RE: TEDS Exception No. 21-03 to Access Spacing at 2321 Logos Drive

DESIGN EXCEPTION #DE21-03

To: Mark Relph, Director of Public Works & Utilities
Thru: Tim Moore, Public Works Manager
Copy to: Eric Hahn, Development Engineer
Pat Cecil, Development Services Supervisor
From: Mike McDill, City Engineer
Date: May 30, 2003
RE: Exception from Access Spacing for 2321 Logos Drive

Project: Folkestad Office/Warehouse
Location: 2321 Logos Drive
Petitioner: Tom Folkestad
2457 Industrial Blvd
Grand Junction, CO 81505

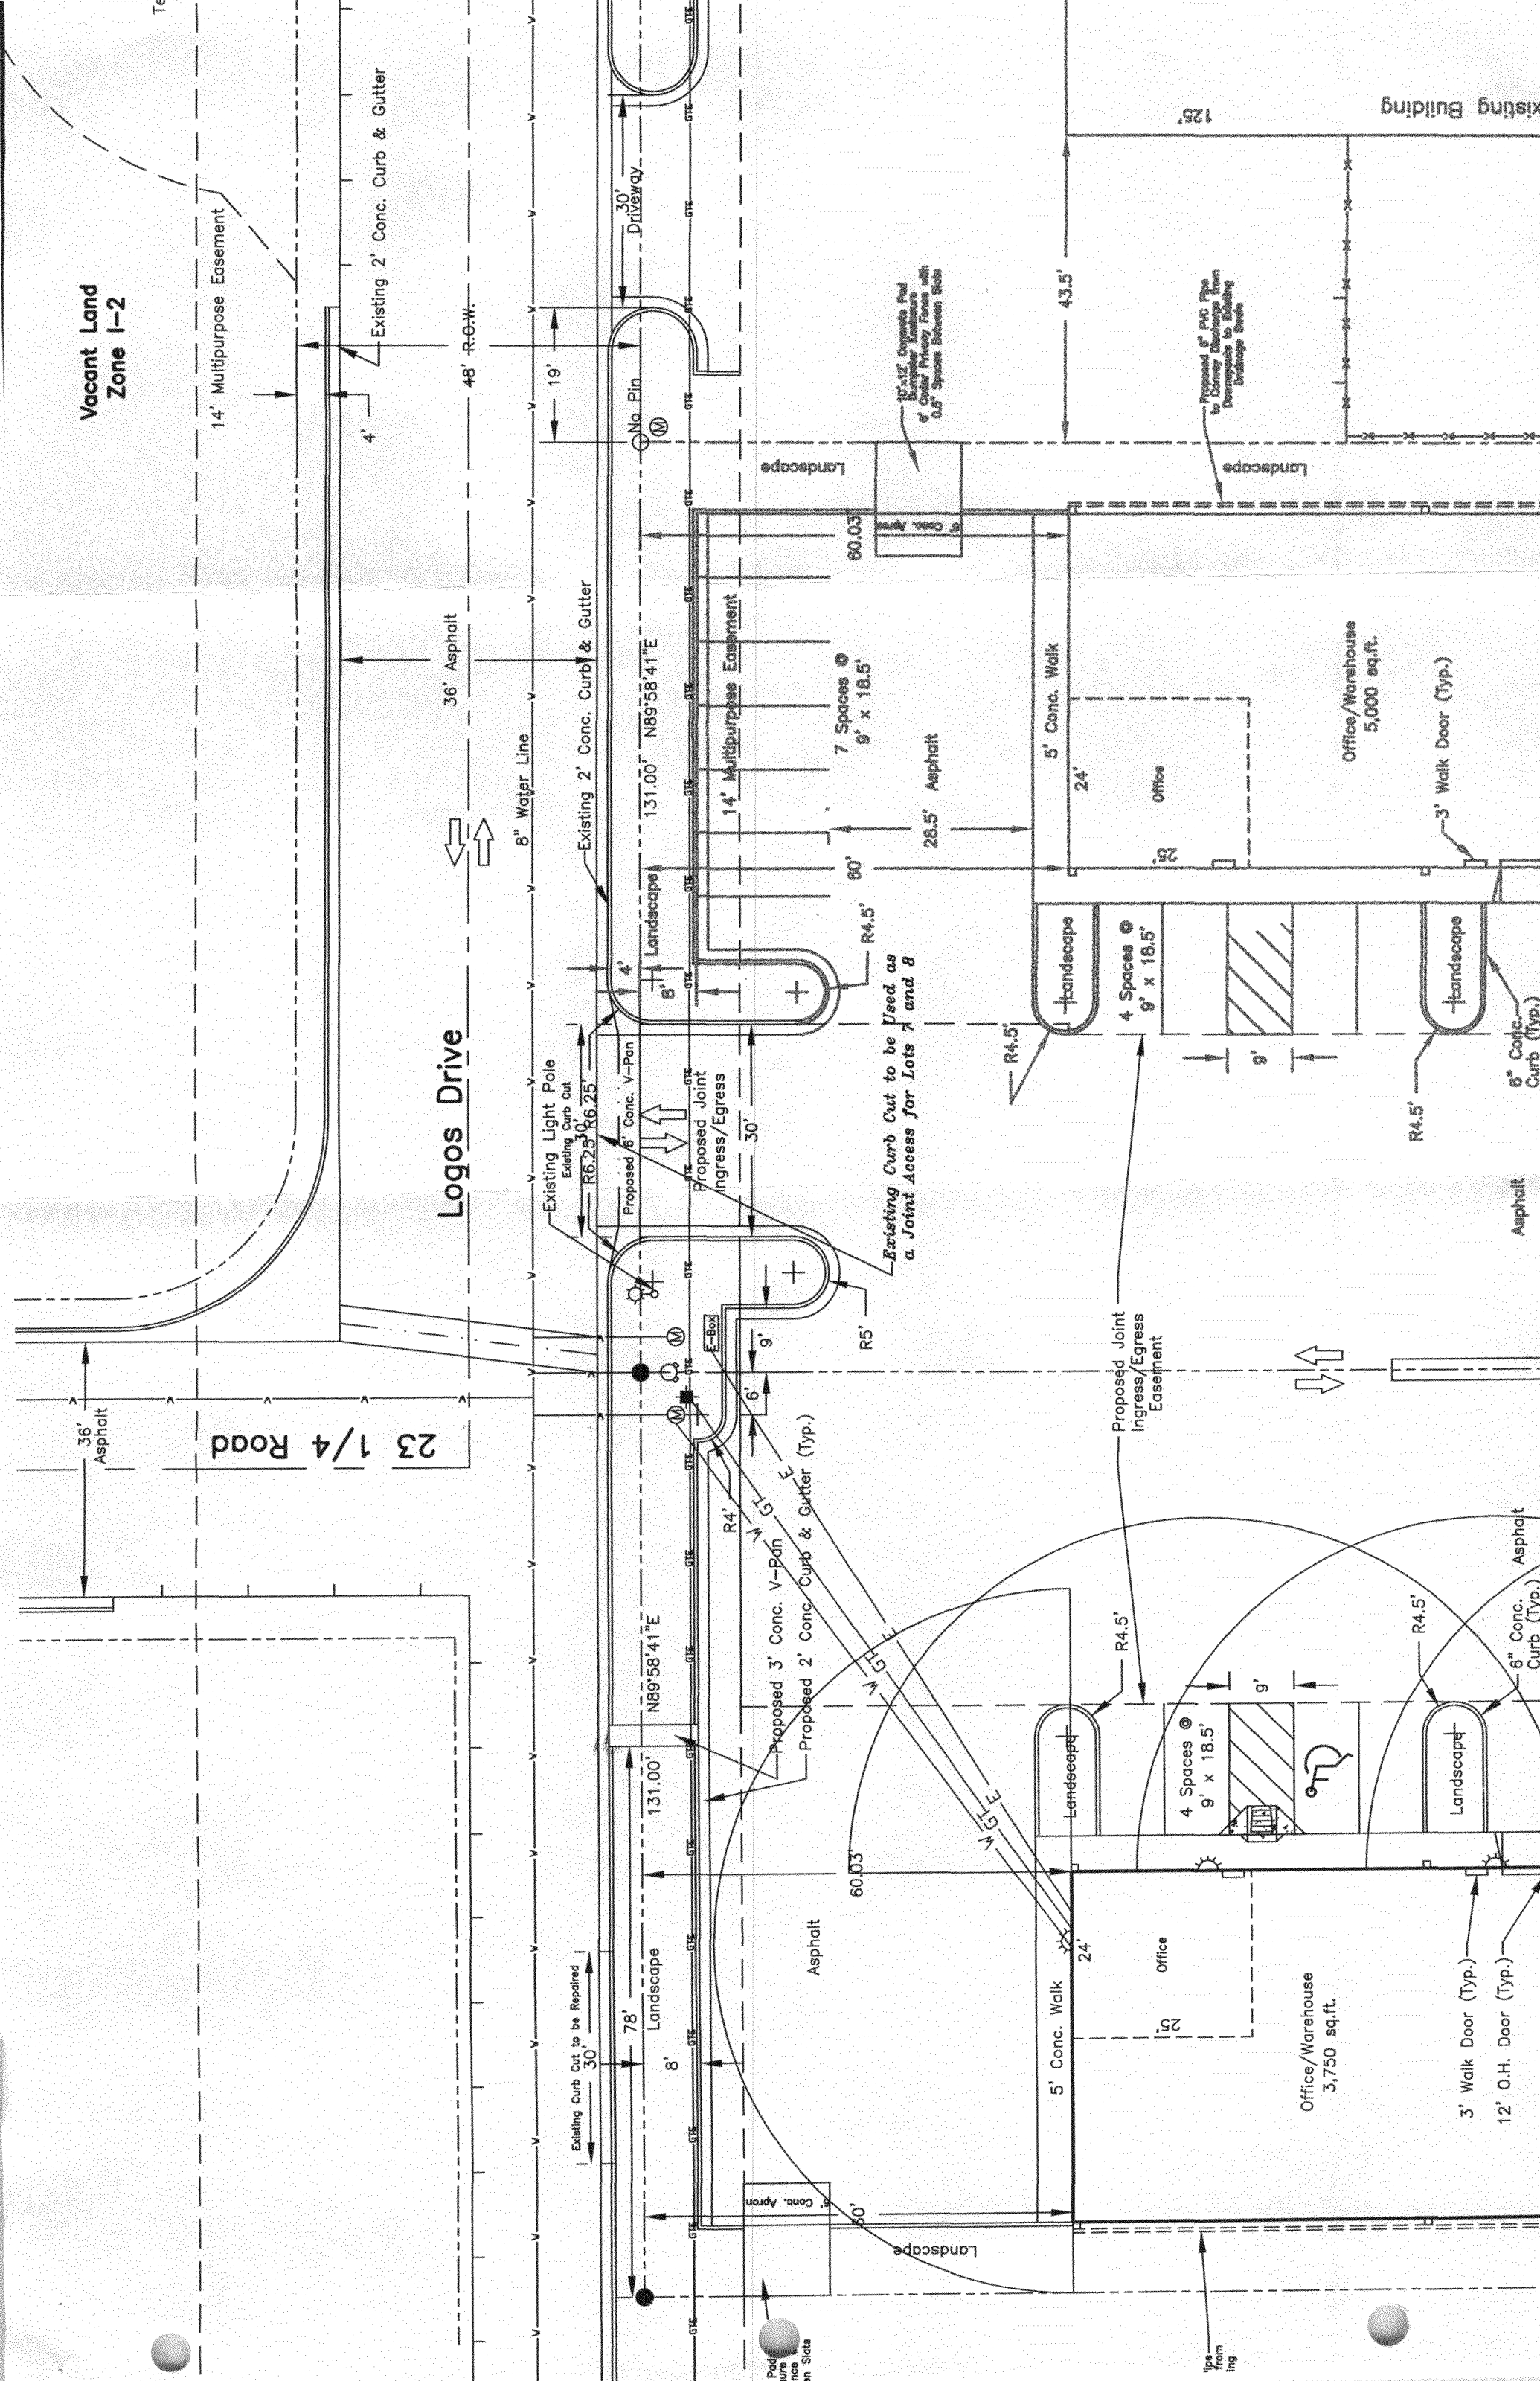
It is our understanding that the TEDS standard, section 4.1.1, has been revised to a 50 ft spacing, center to center, for adjacent and opposite driveways and intersections. Thus, we are requesting an exception of 3 ft to the spacing requirement.

It seems that the requested exception to TEDS is outweighed by the advantage of **combining 2 existing accesses into 1** and placing the **driveway in a location which will facilitate large truck access to the site.**

The existing and proposed accesses are shown on the attached drawing. Please consider this request for exception and let us know your decision at your earliest convenience.

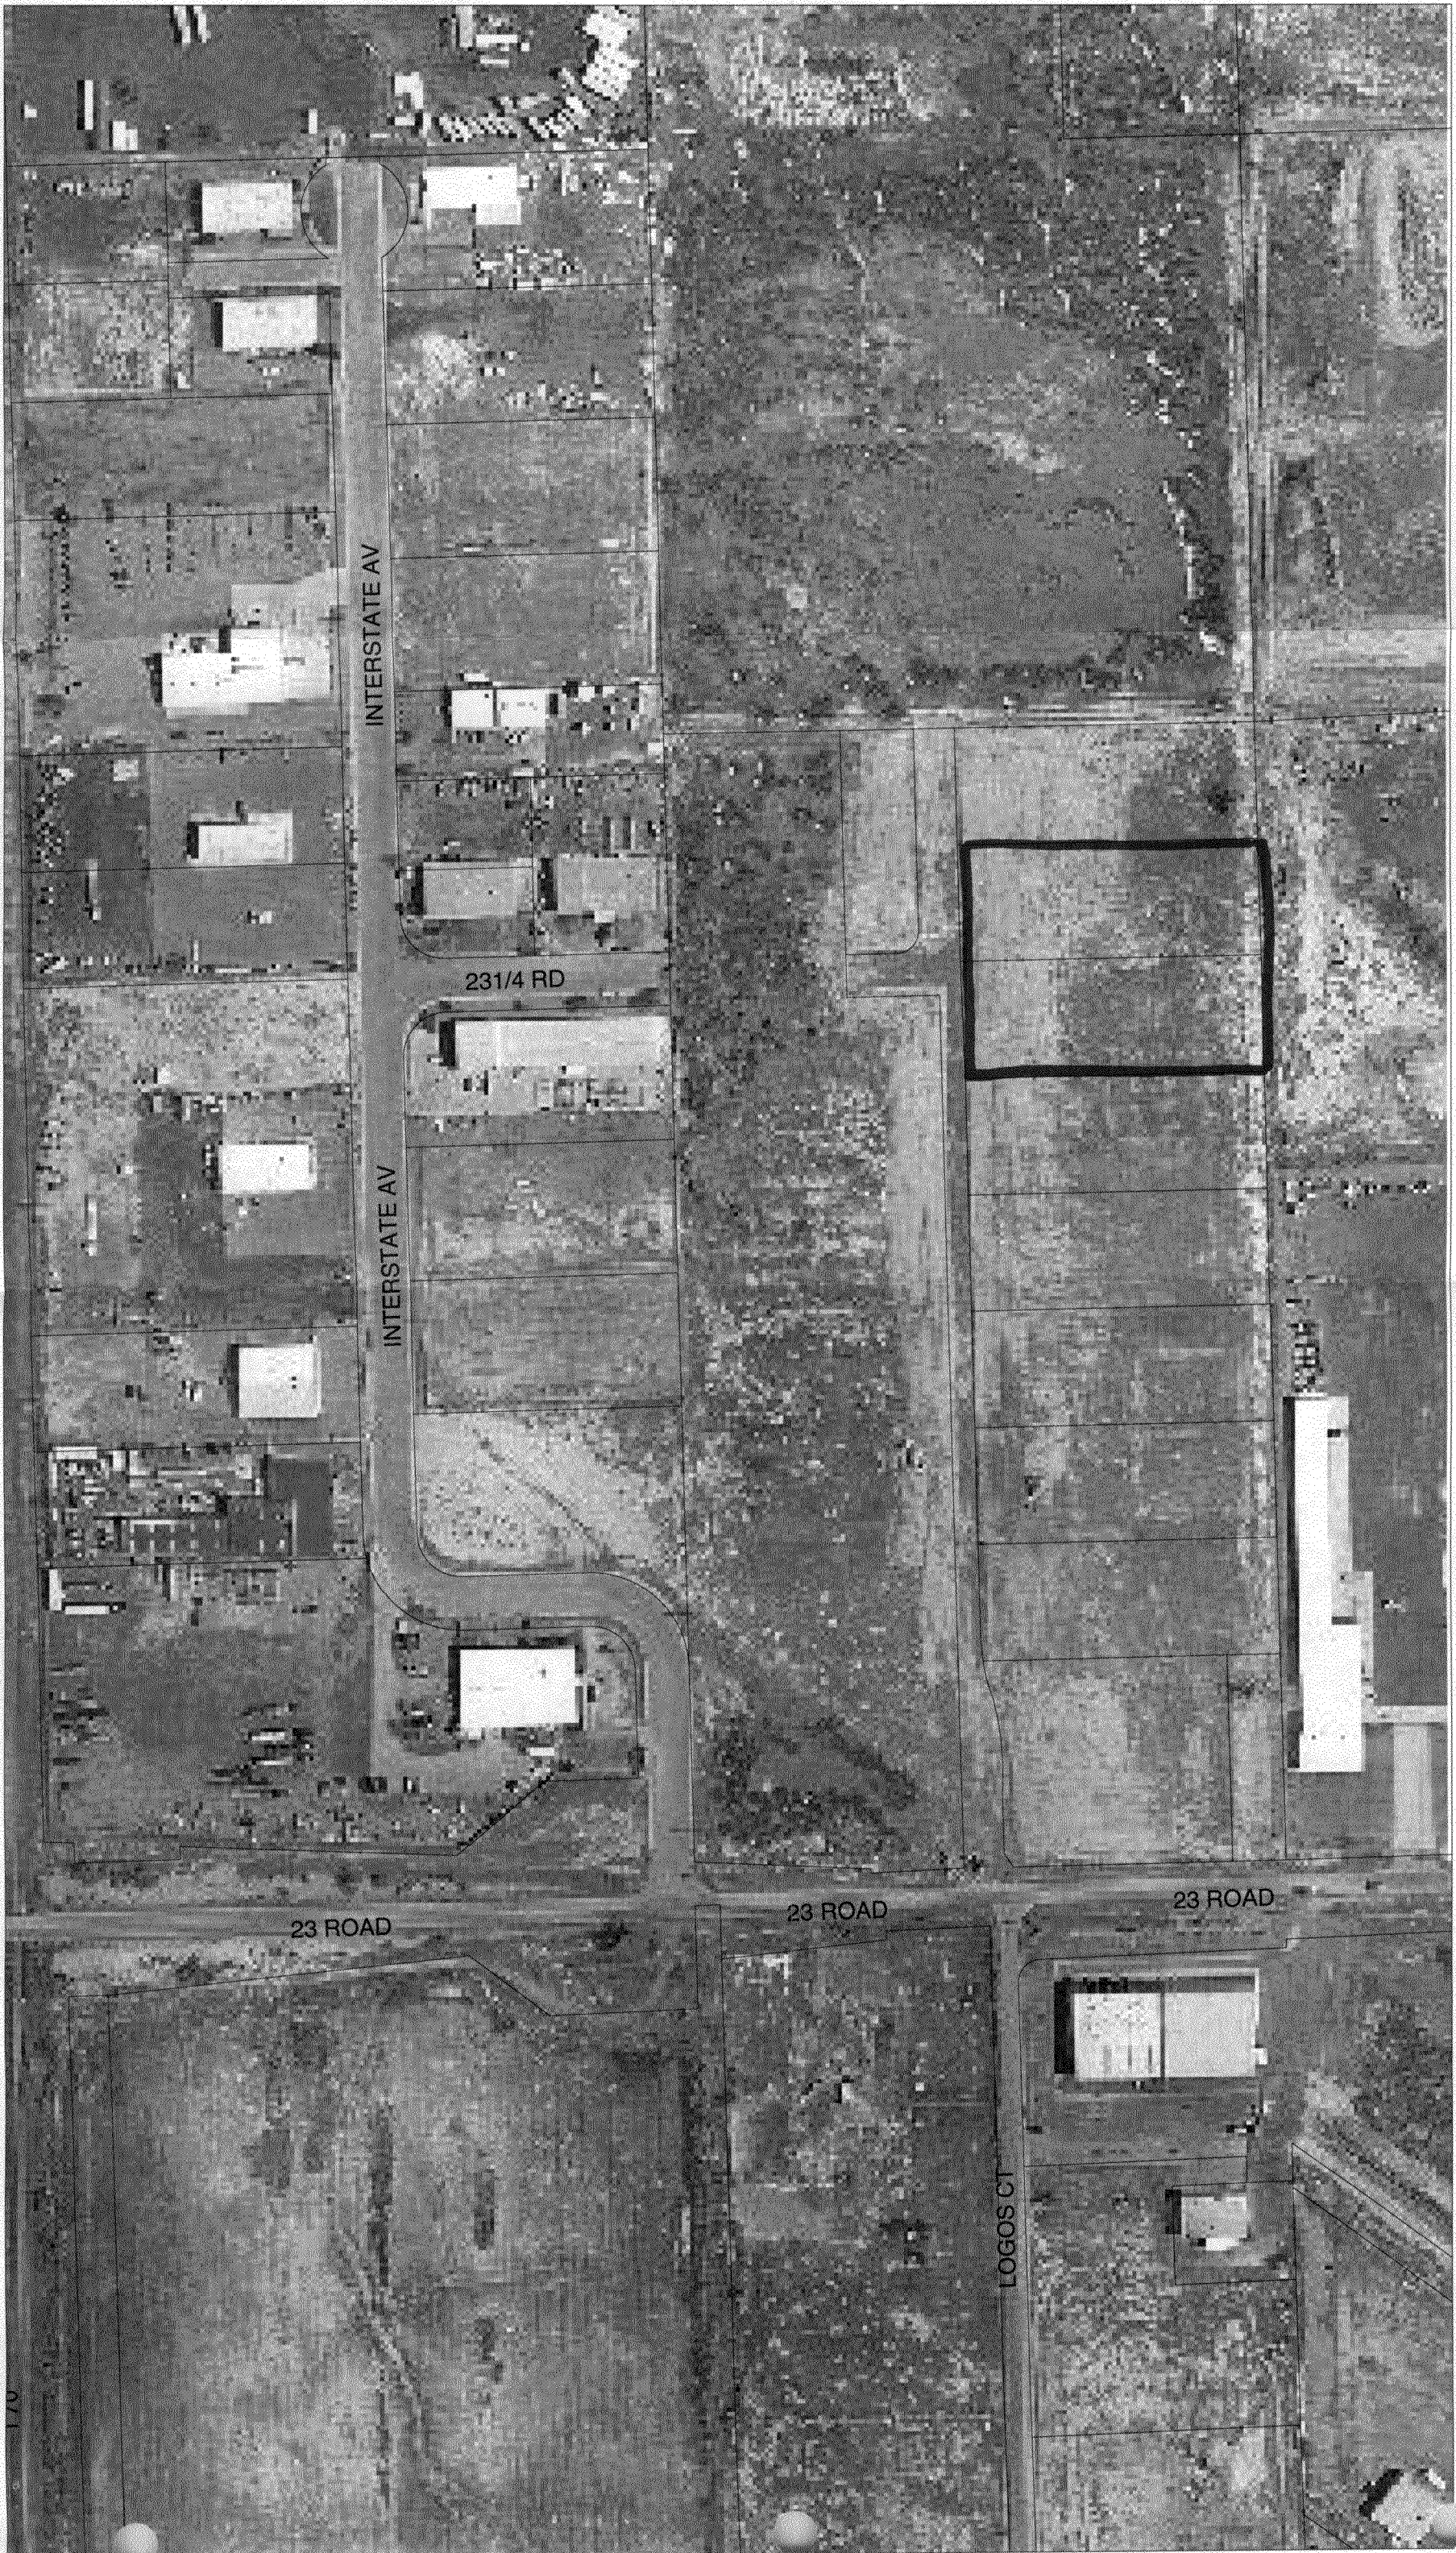
This request appears to be appropriate and warranted. I agree with the applicant's reasoning that is expressed in the request. The combined access will probably cause less problems than two individual accesses to these lots that may or may not be able to meet TEDS spacing requirements. The applicant is striking middle ground that is probably the best possible solution given the proposed building sizes and site layout. In addition, this is an industrial street that will have very low traffic volumes. In summary, I recommend that this exception be granted.
